SERVICE BULLETIN

SUBJECT: Advice of Misc. Changes (Video)

1. Change in Servo Circuit of VT-110

Fig. 1

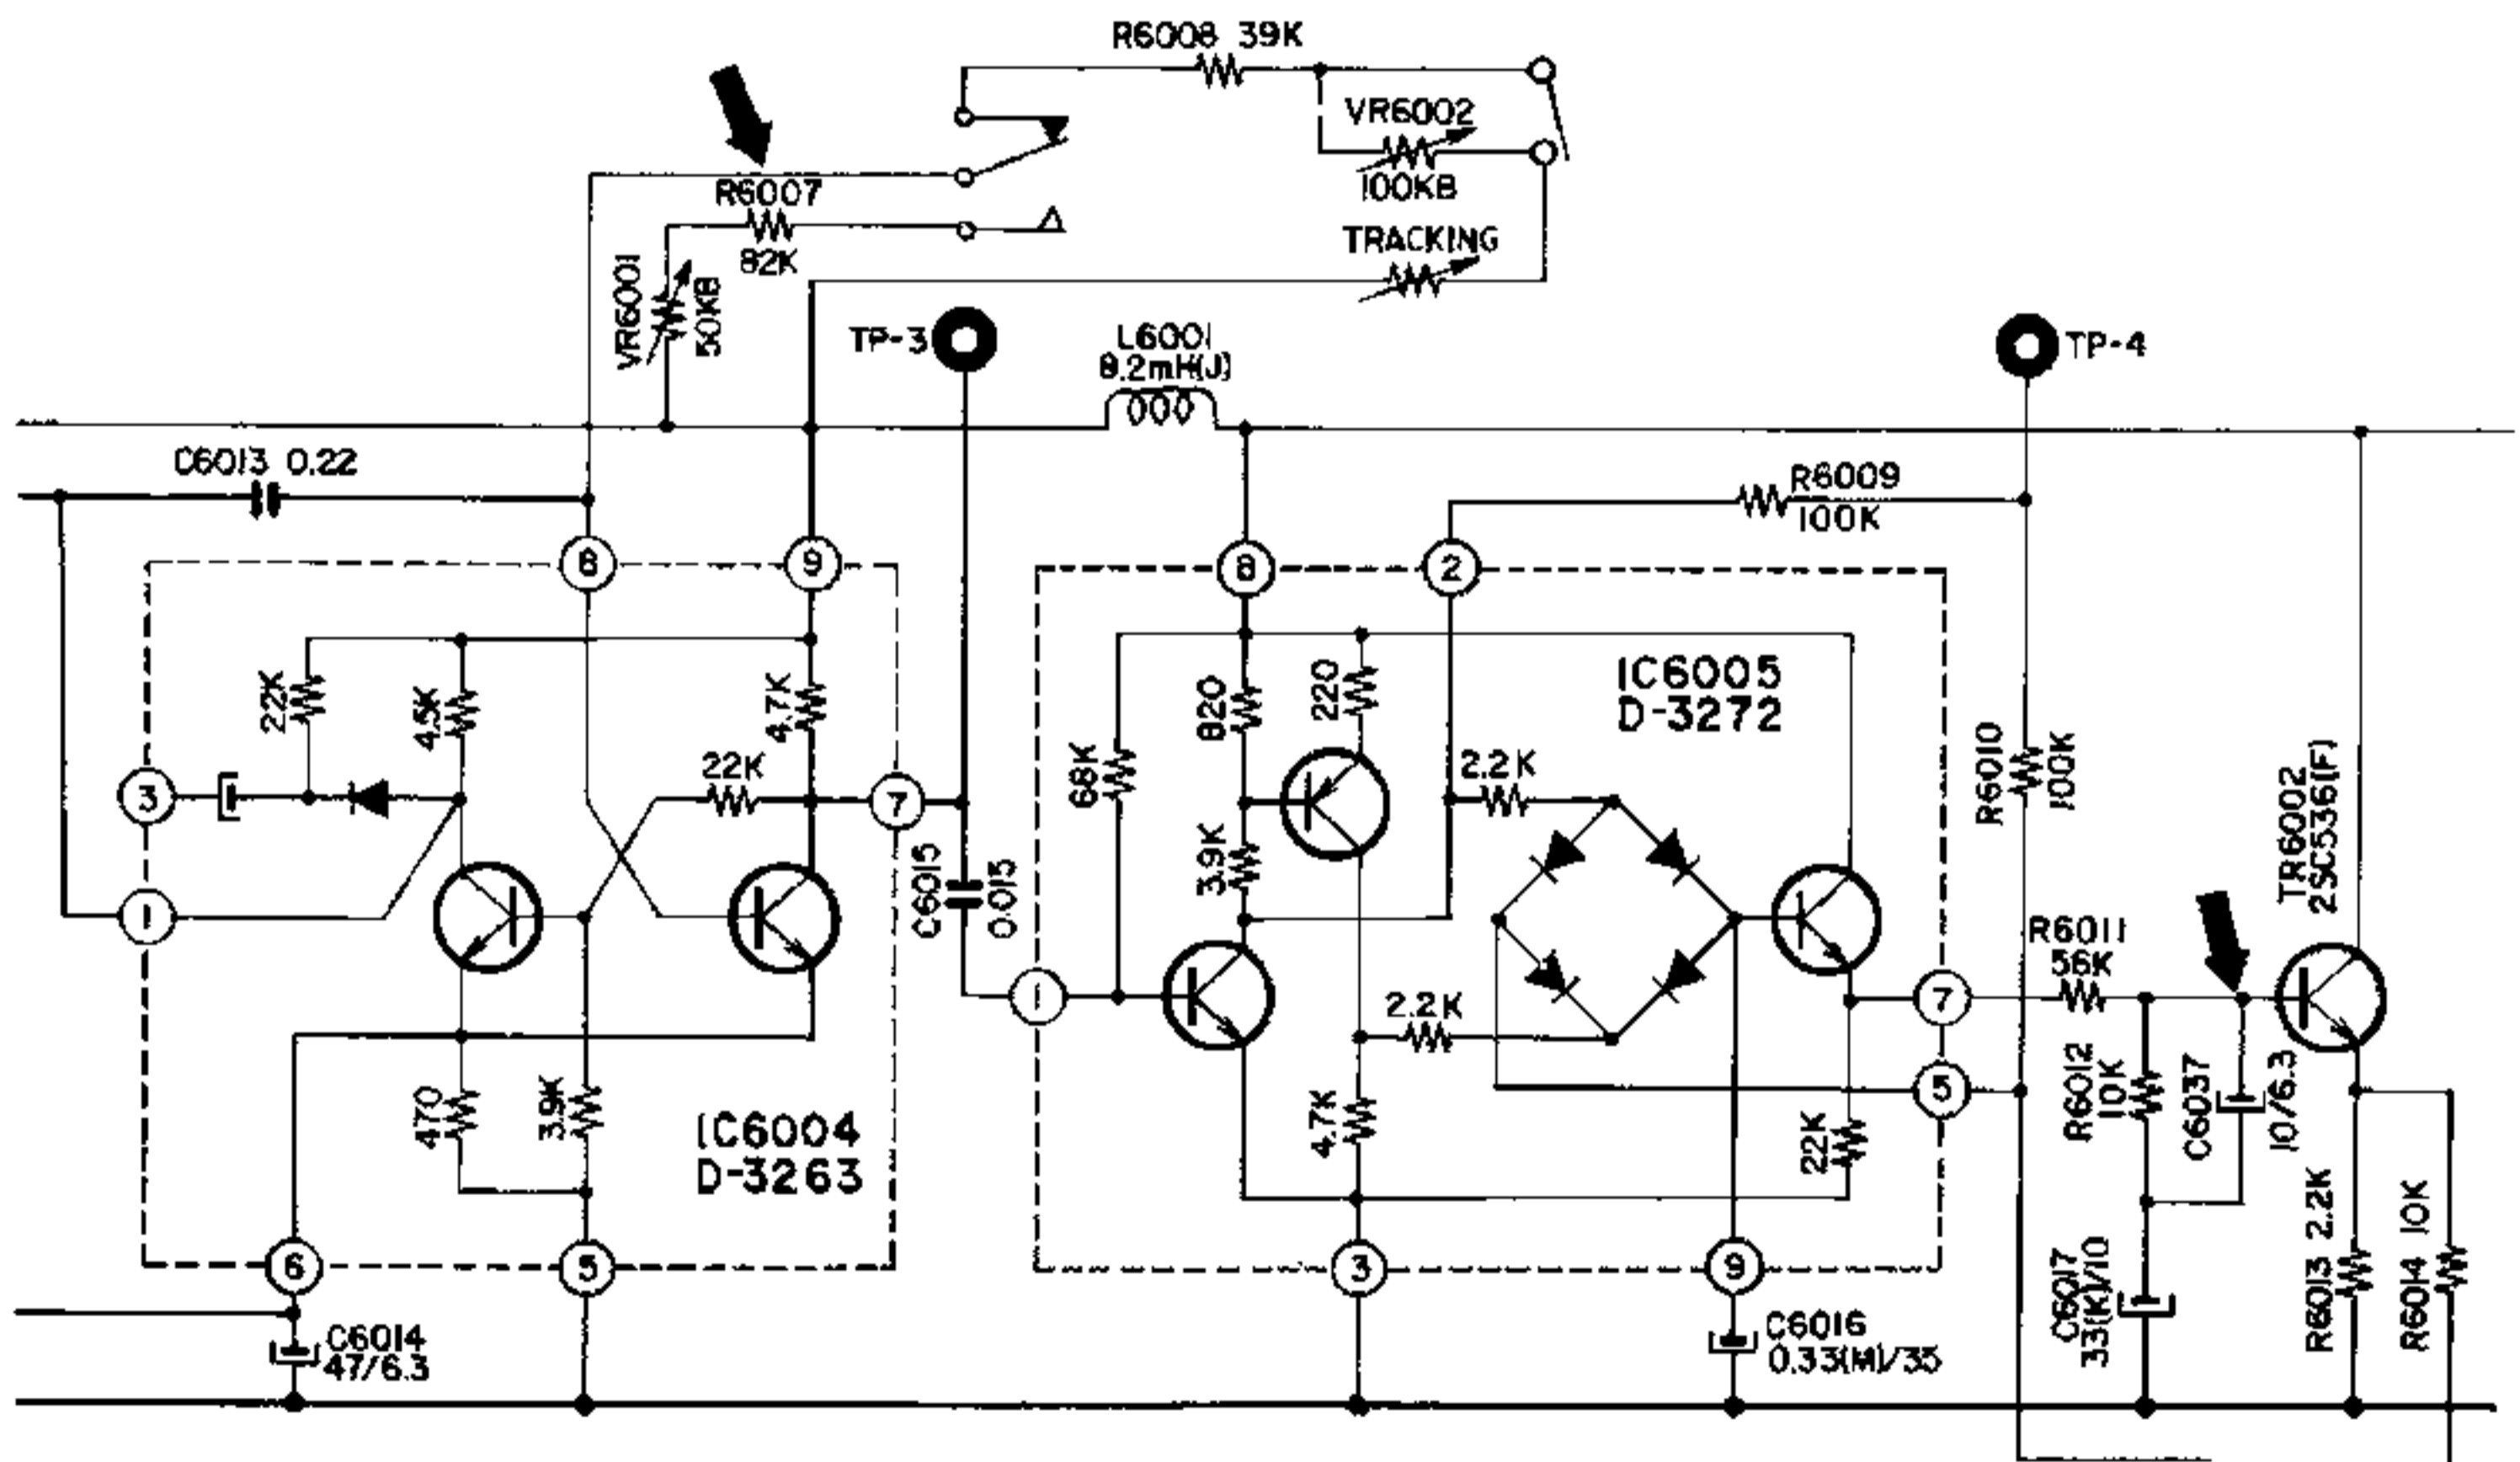
- i) Resistor R6007 68 kΩ in Multi-Vibrator circuit of C.C.I.R. type Servo P.C. Board has been changed to 82 kΩ.

Explanation: Because there were cases in which the tracking pulse width could not be adjusted.

- ii) Condenser C6037 10 μF/6.3V has been supplemented in transistor TR6002 Base circuit of U.S. type Servo P.C. Board.

Explanation: To eliminate a swaying picture.

Fig. 2

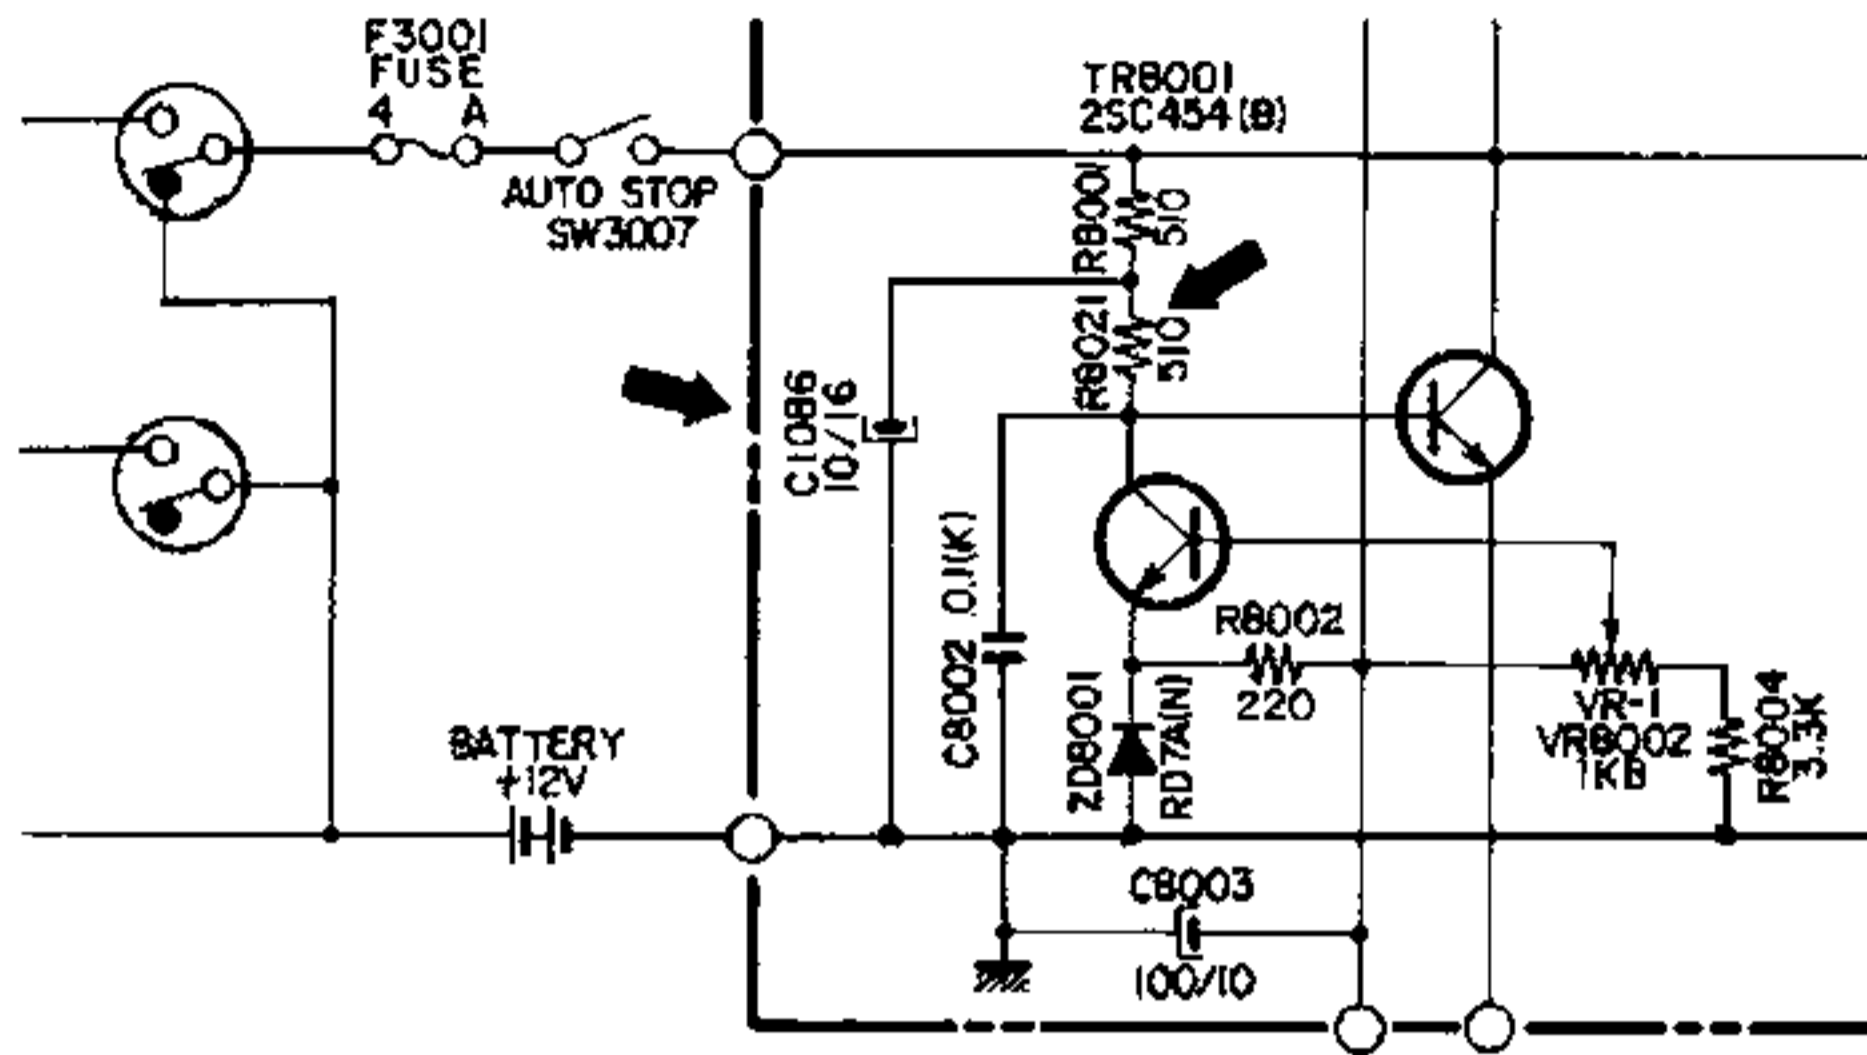
Resistor R8001 2.2 k Ω in 9V Regulator circuit of Motor Drive & Power Supply P.C. Board has been changed to 510 Ω , and Resistor R8021 510 Ω and Condenser C1086 10 μ F/16V have been supplemented.

Explanation: To eliminate flickering on Monitor screen during recording mode at lower voltage.

Fig. 3

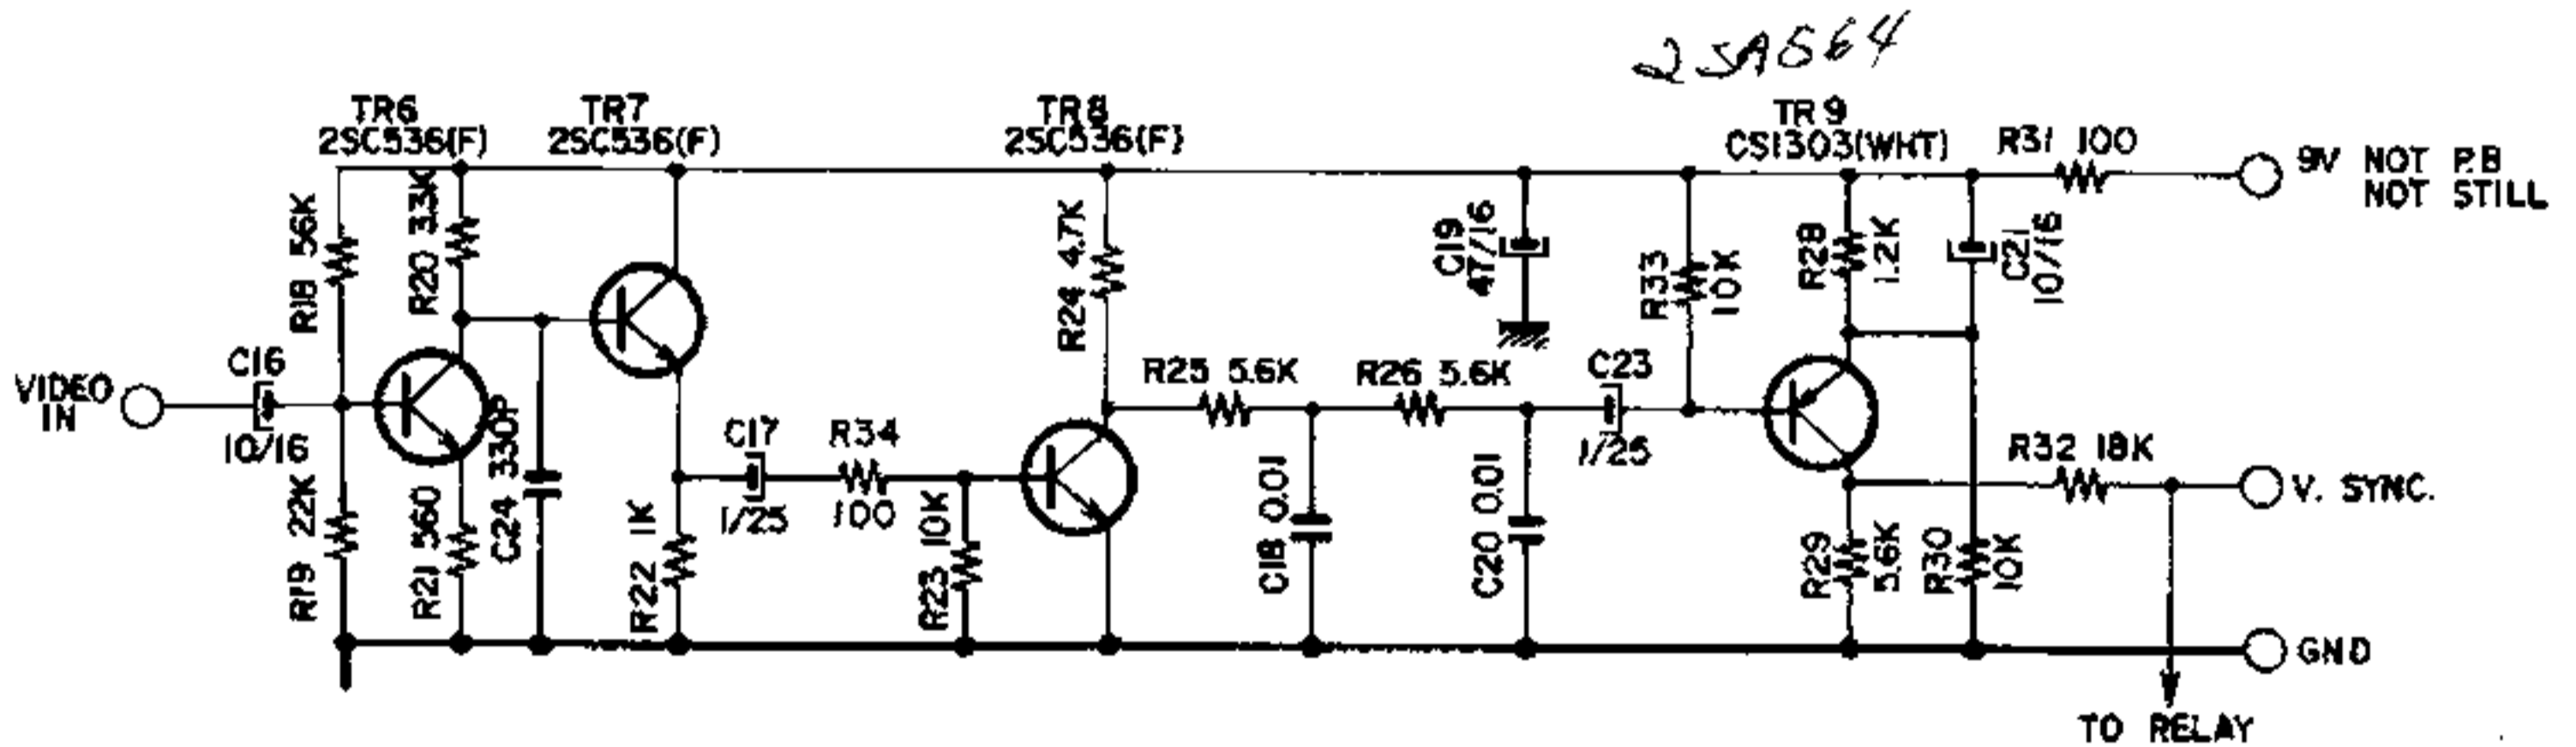
To improve stability of video switching point when dubbing or when recording with T.V. Tuner Adaptor, the Sync. Signal Separator circuit has been changed as shown in the diagram below.
